ADDENDUM NO. 5

BAGGAGE EXPANSION

Northwest Florida Beaches International Airport
6300 West Bay Parkway
Panama City, Florida 32409
Phone: 850-763-6751

Date of Issue: May 19, 2022

SHEET NUMBER
A-2.0.3

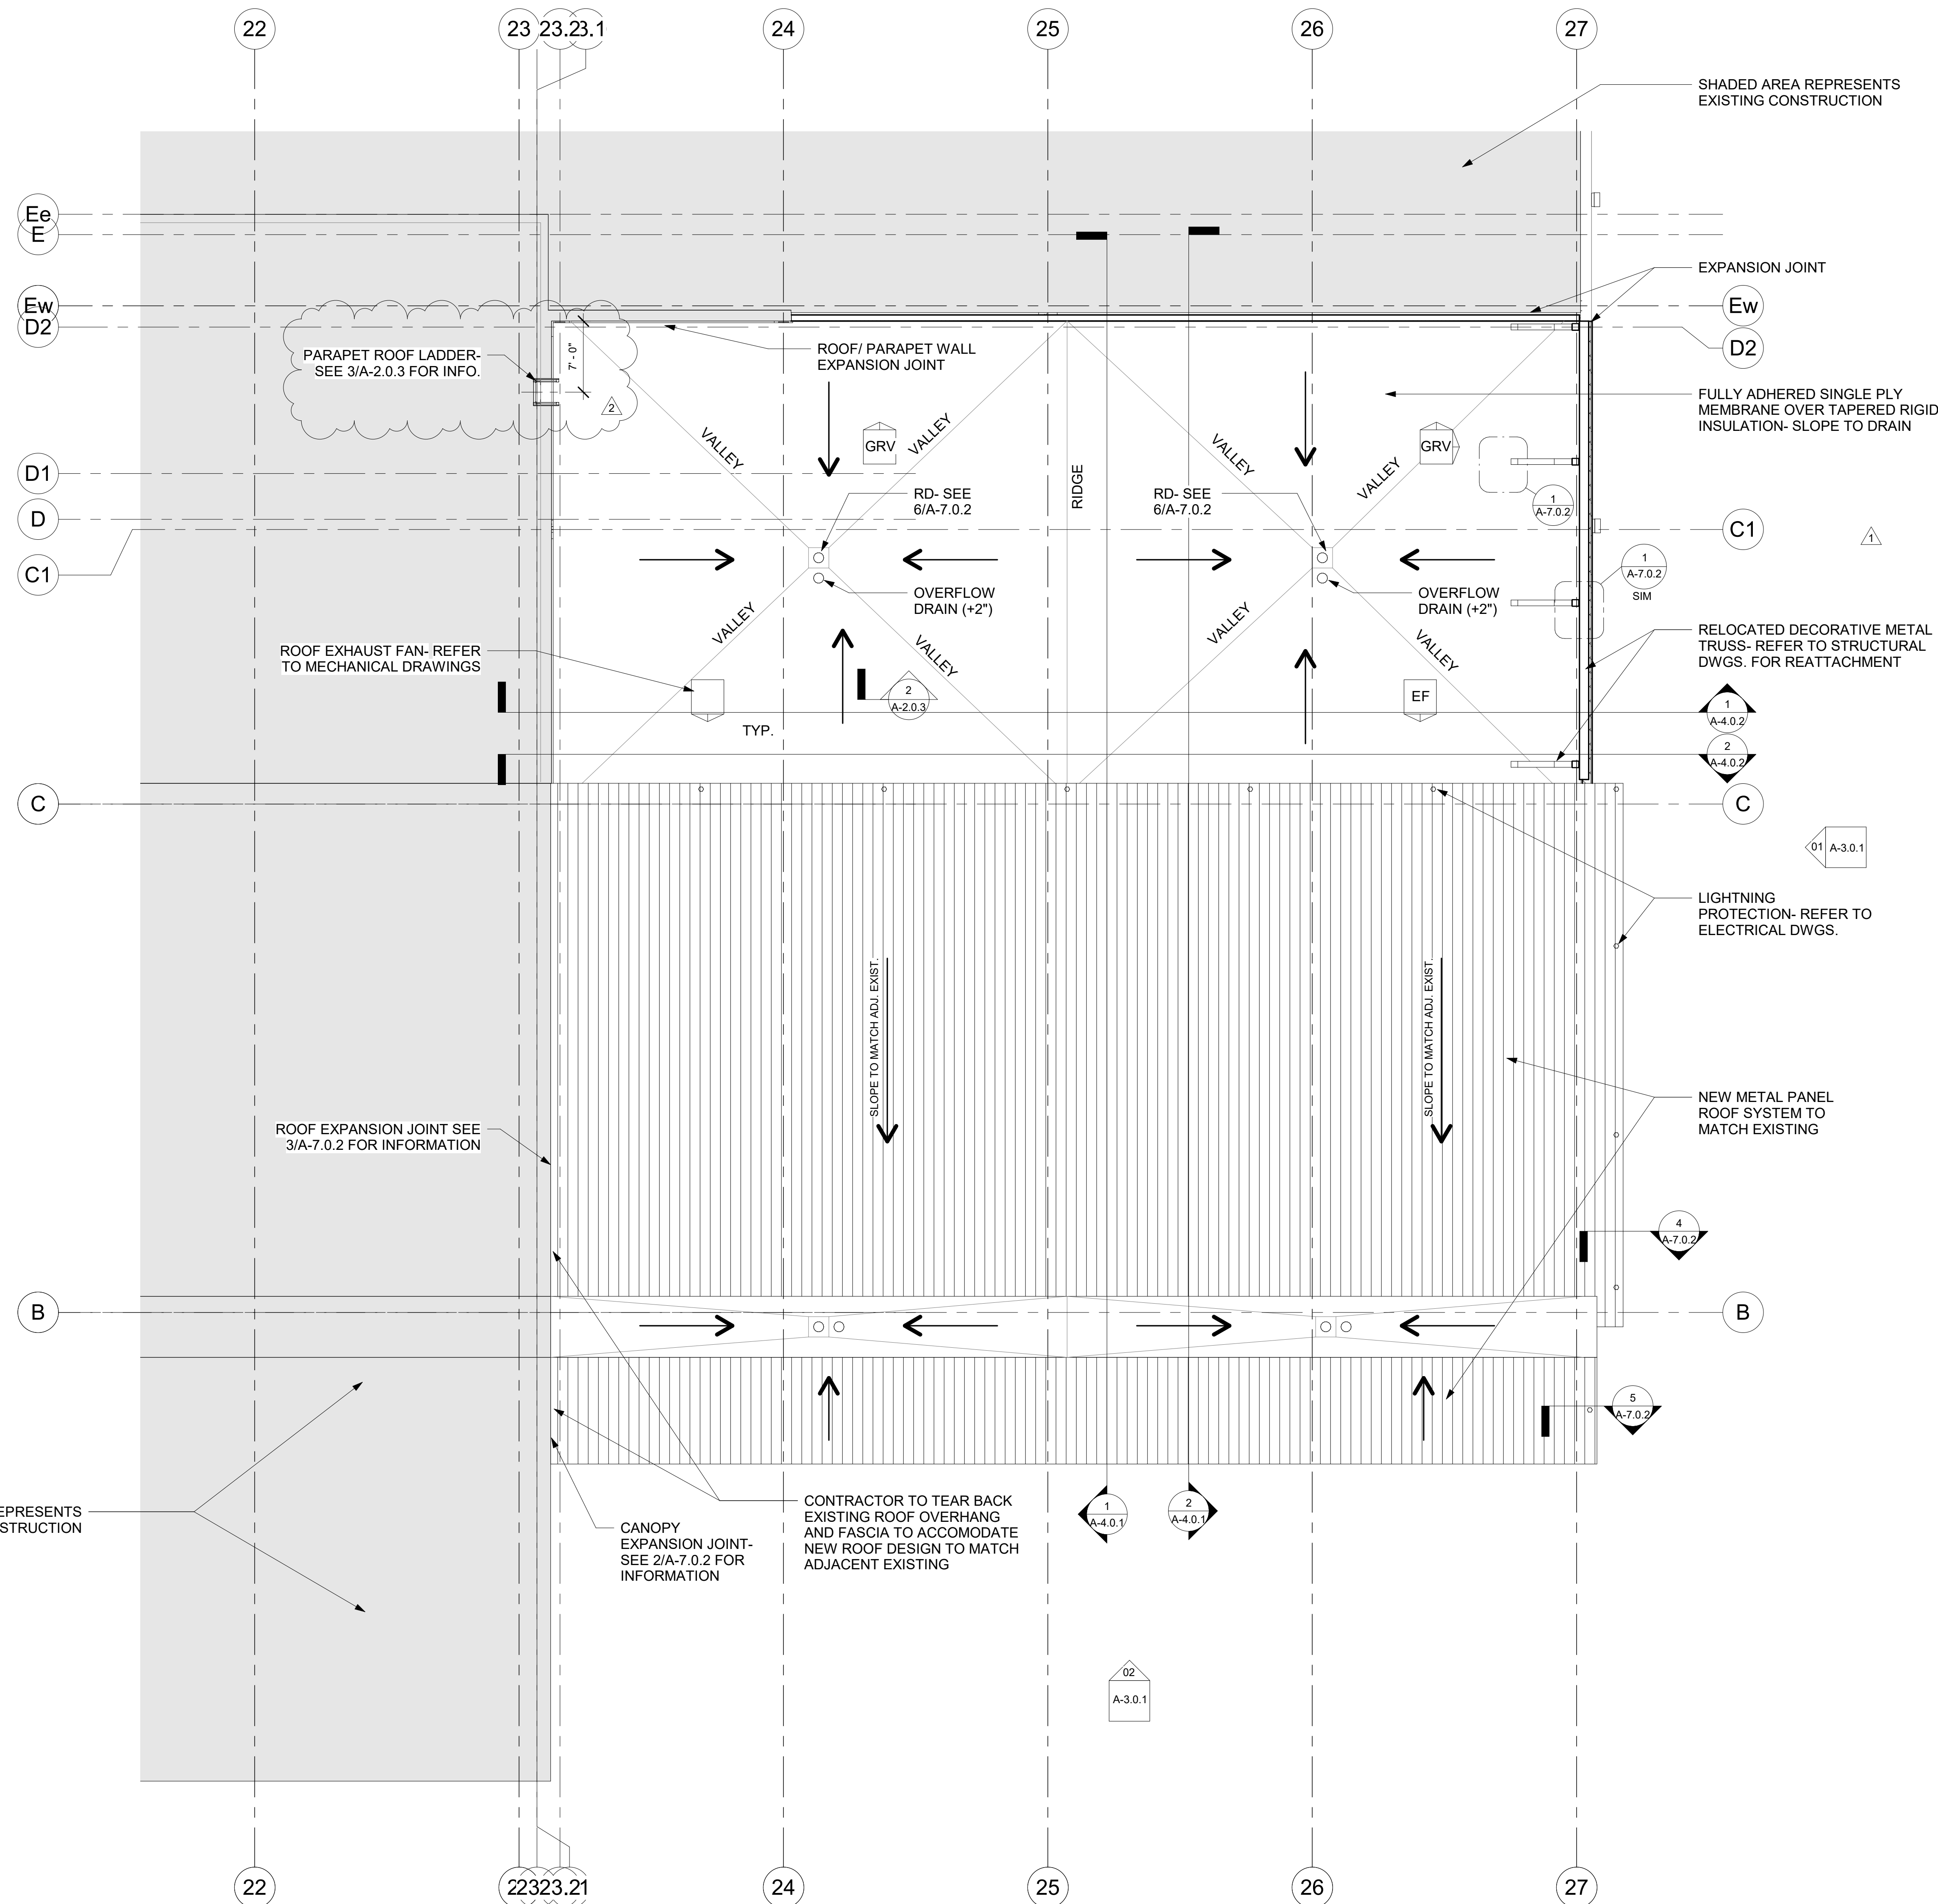
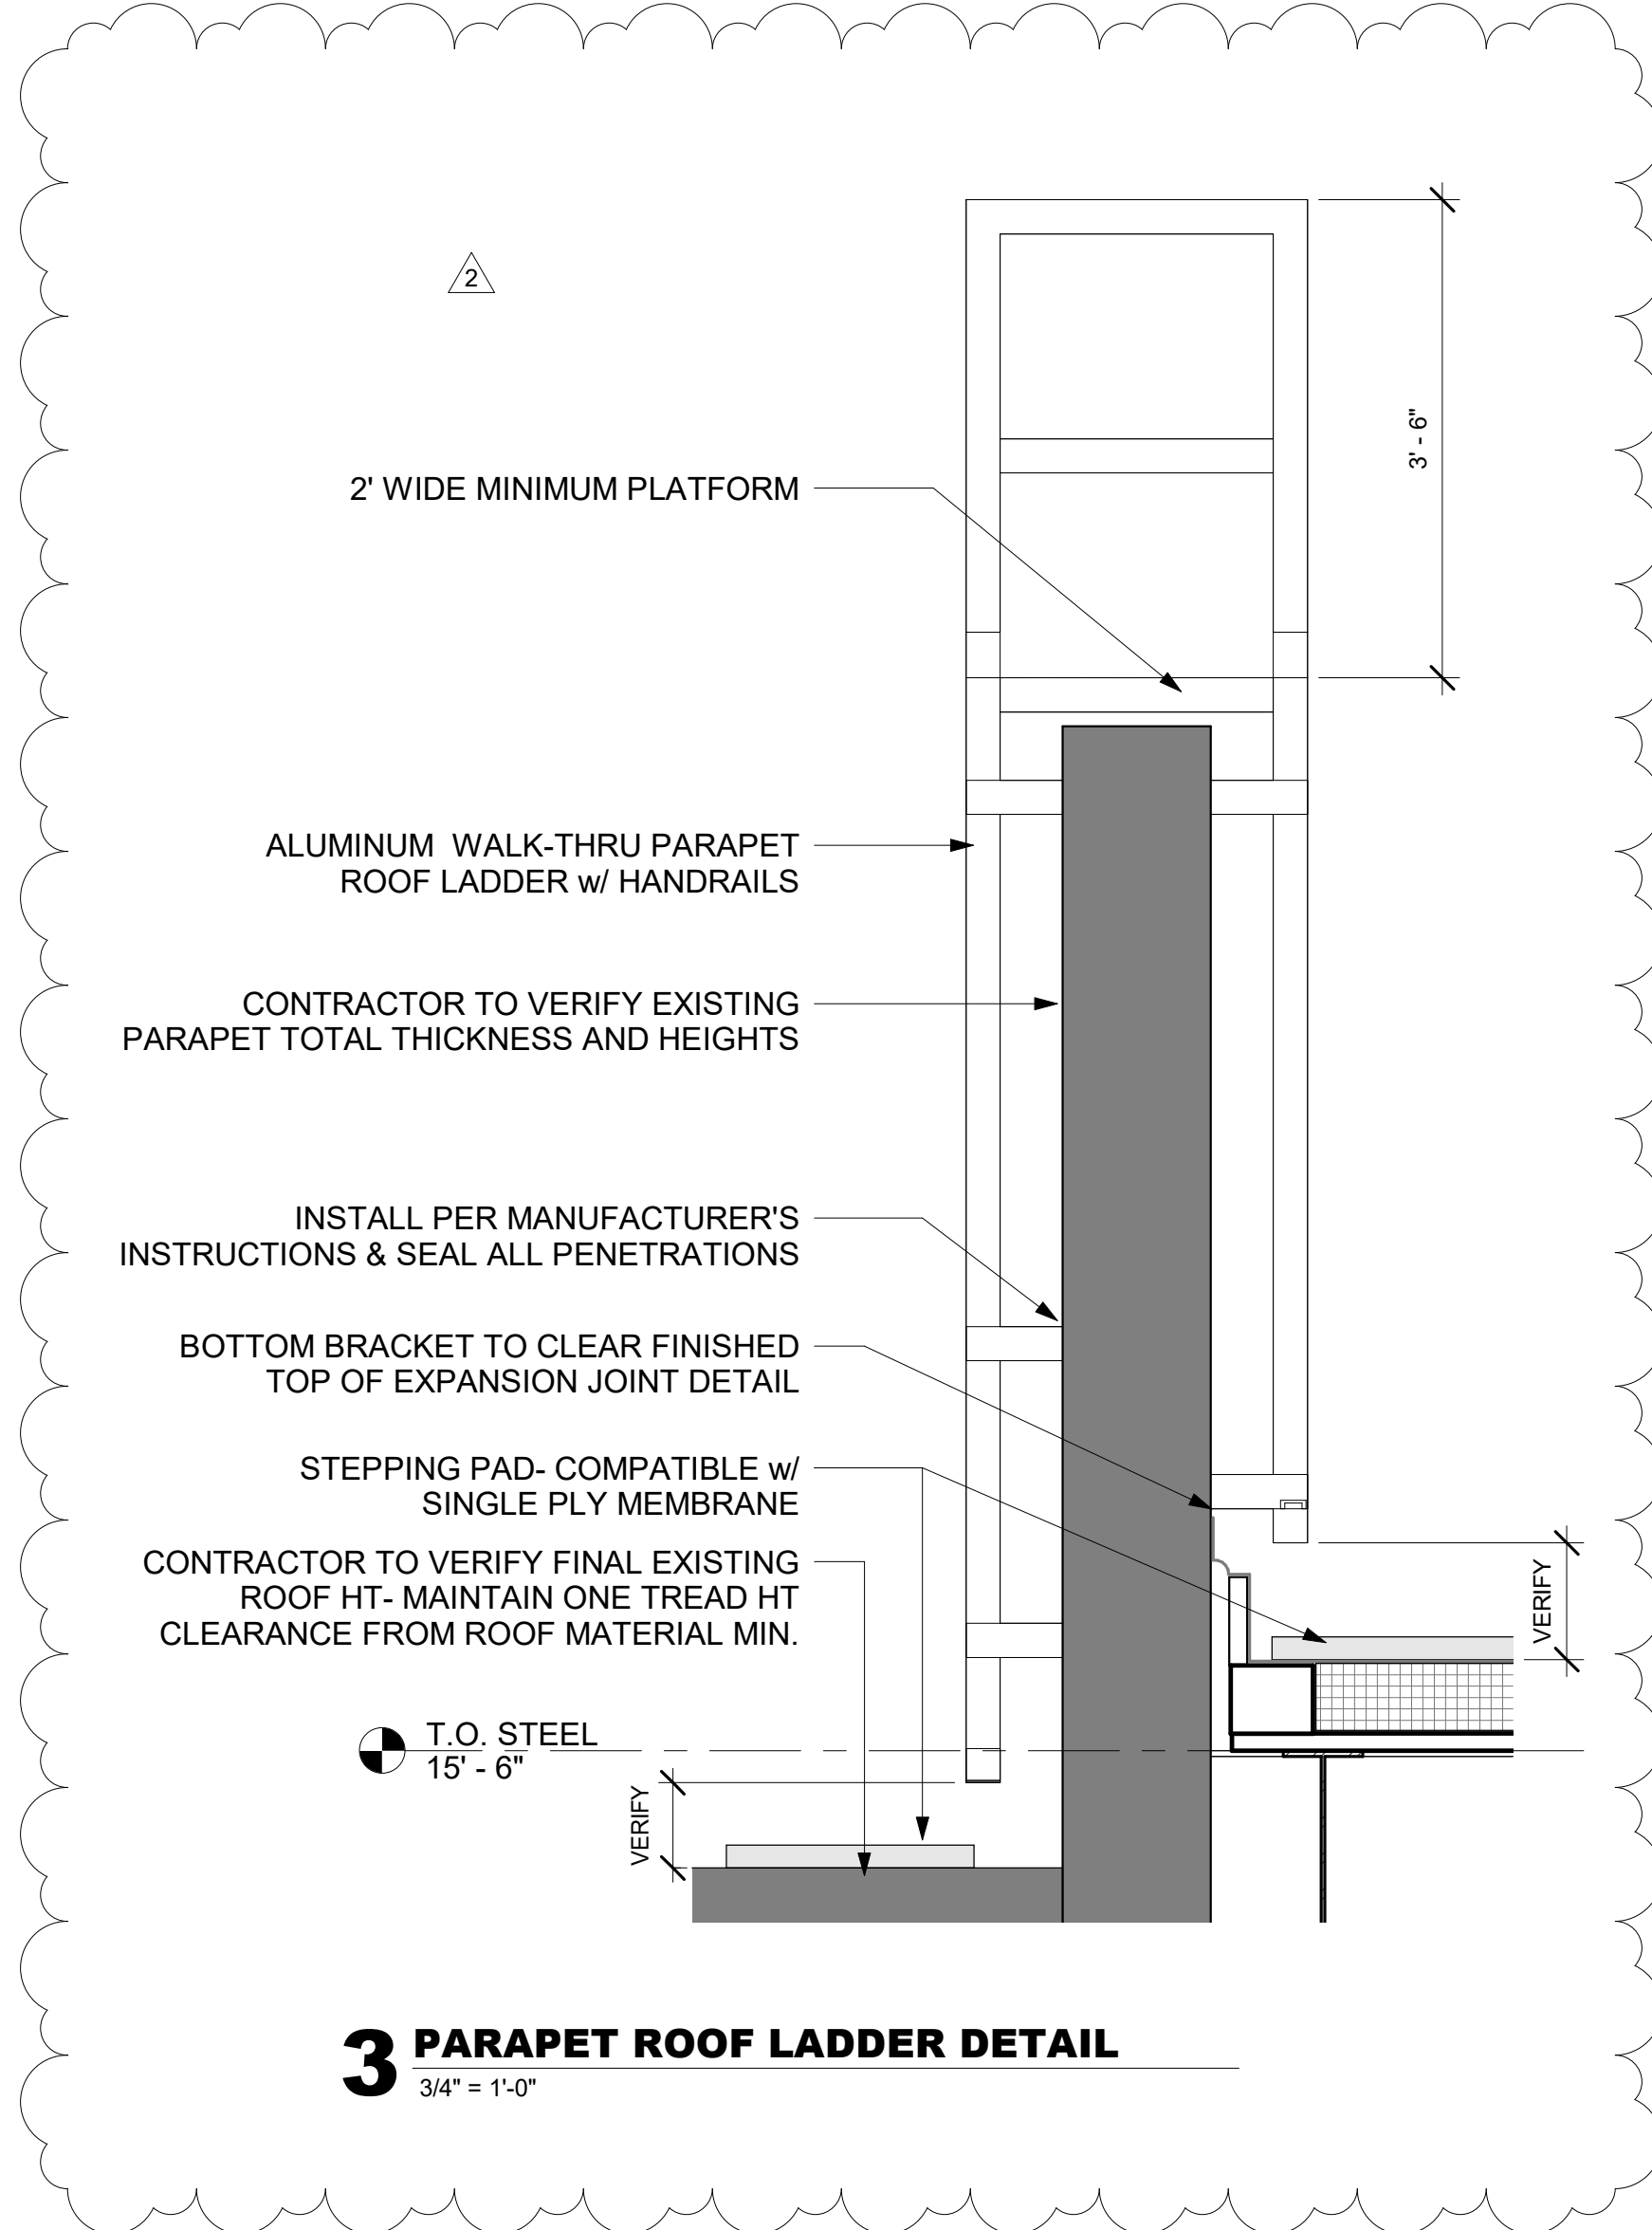
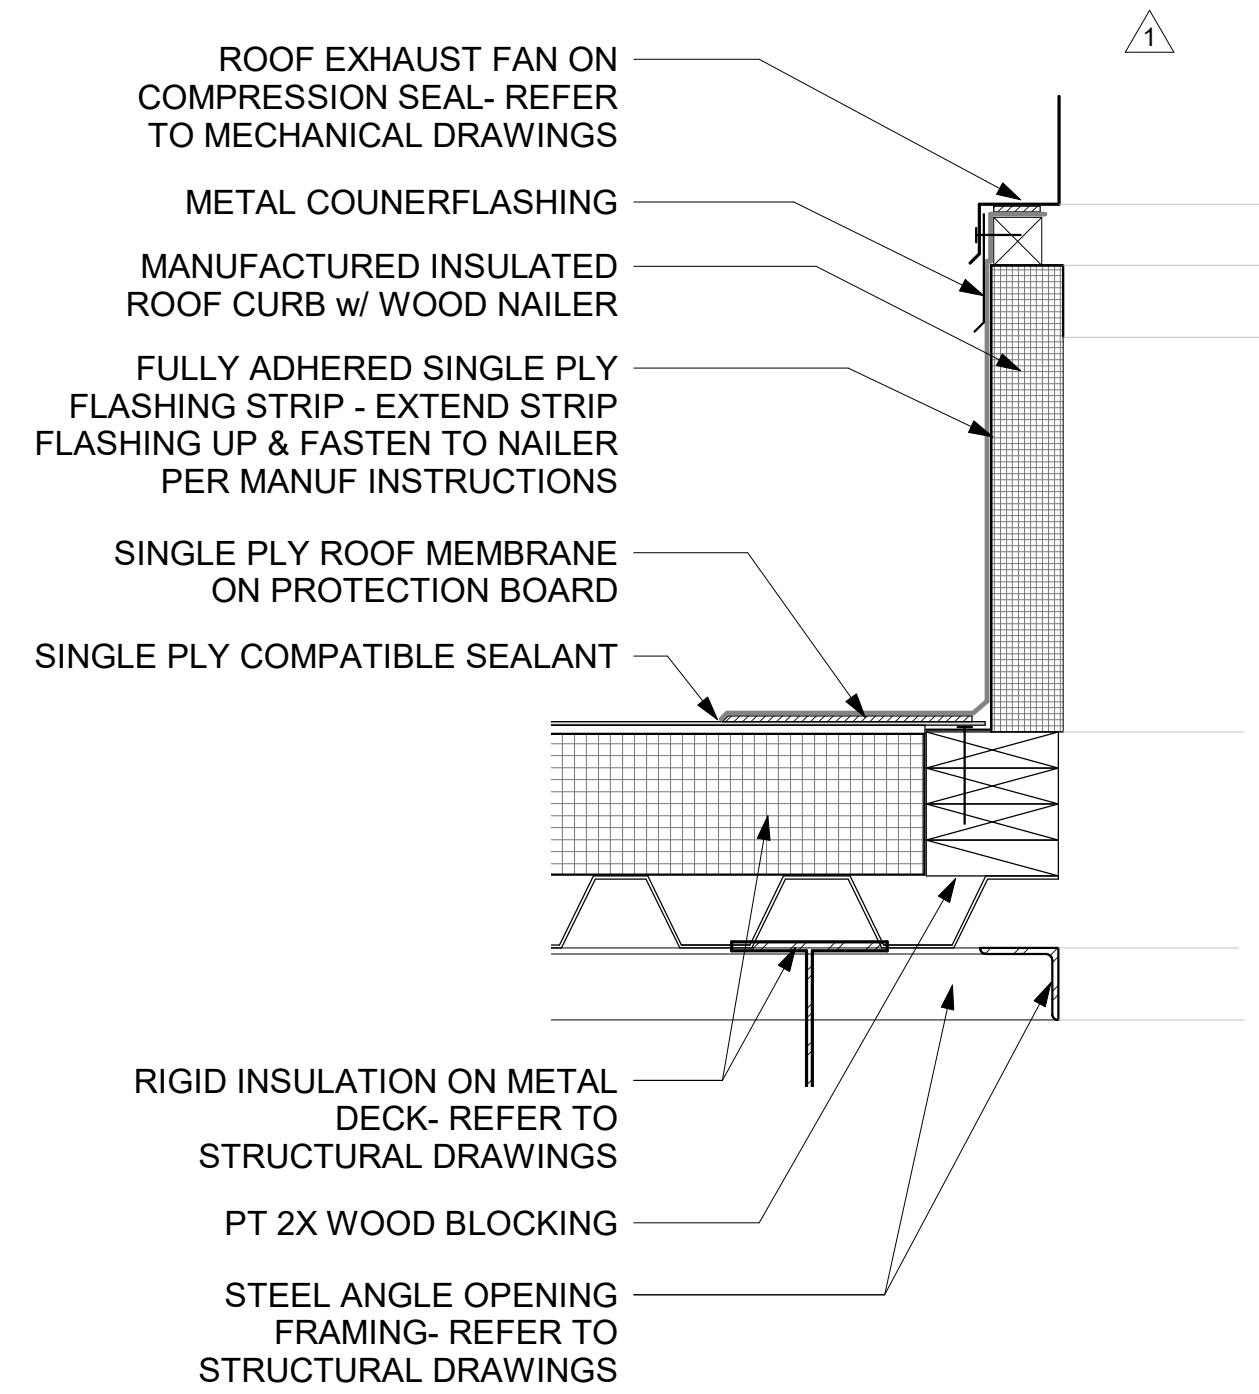
- A. ARCHITECTURE
 - a. REVISED: A-2.0.2 FLOOR PLAN, amend notes re: concrete floor sealer and rubber wall base
 - b. A-2.0.3 ROOF PLAN, added parapet roof ladder, added parapet roof ladder detail
 - c. REVISED: A-4.0.1 BUILDING SECTIONS, added parapet roof ladder
 - d. REVISED: A-4.0.2 BUILDING SECTIONS, added parapet roof ladder, revised/added GRV units to rooftop for clarity
